SERVICE LETTER

No. 770

Piper Aircraft Corporation

Subject: Aileron Sprocket/Chain Inspection.

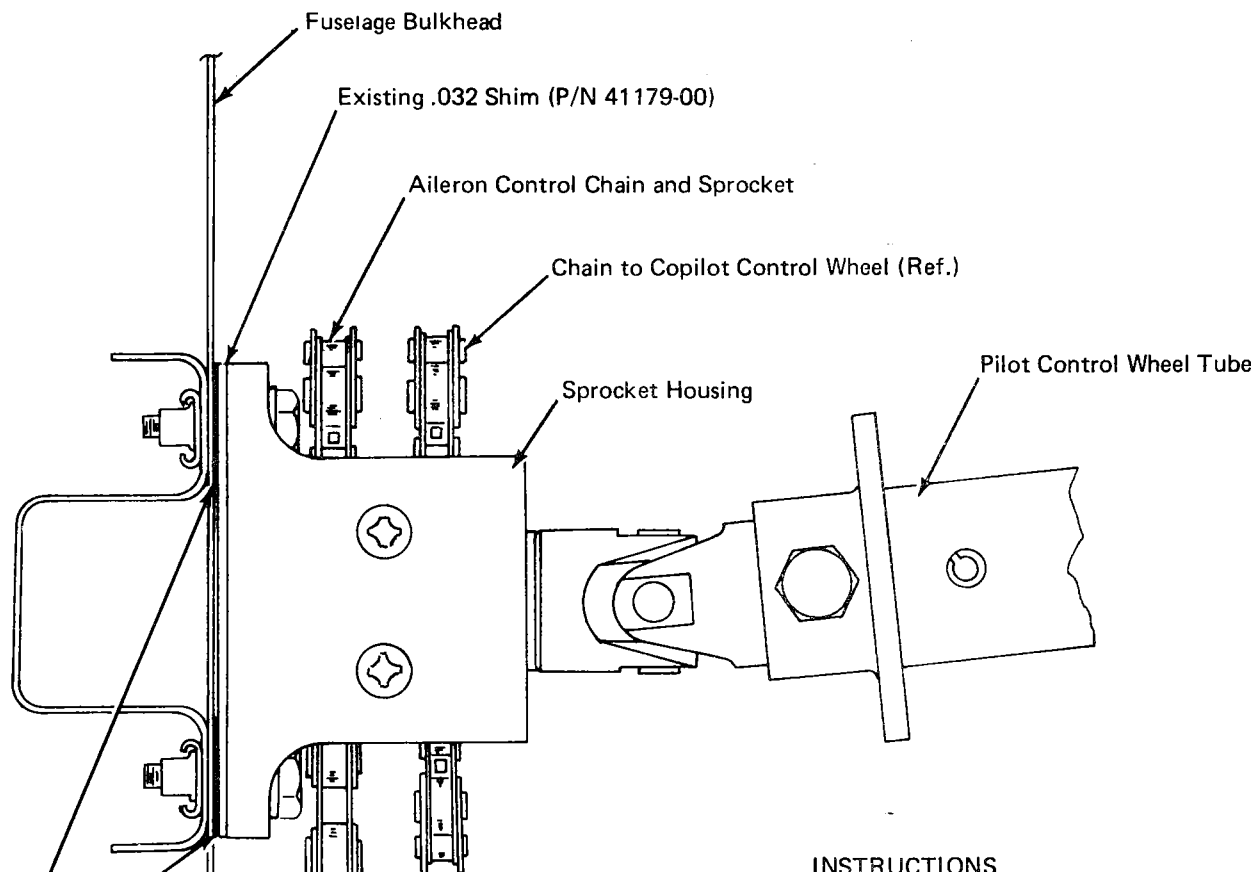
A report has been received from the field describing rough, "articulated" rotation of the pilot's control wheel. During corrective action, it was determined that the aileron sprocket and mating aileron control chain were misaligned, causing the chain to bind on the sprocket teeth. In addition to the above referenced roughness of operation, this condition, if not corrected, could cause eventual sprocket and/or chain wear.

This service release provides instructions for inspection of the aileron sprocket/aileron control chain for proper alignment and operation, and, if necessary, to reposition the sprocket assembly to gain proper alignment.

- a. Inspect at outboard end of sprocket housing to determine if the .032 shim (P/N 41179-00) is installed between the offset in the housing and the bulkhead. Install shim (P/N 41179-00) if it is not present. This shim will ensure proper horizontal alignment.

- b. To attain proper vertical alignment, install new .012 shims (P/N 55817-02) between the top or bottom of the sprocket housing and the bulkhead, as required, to ensure a smooth flow of the chain links over the sprocket.
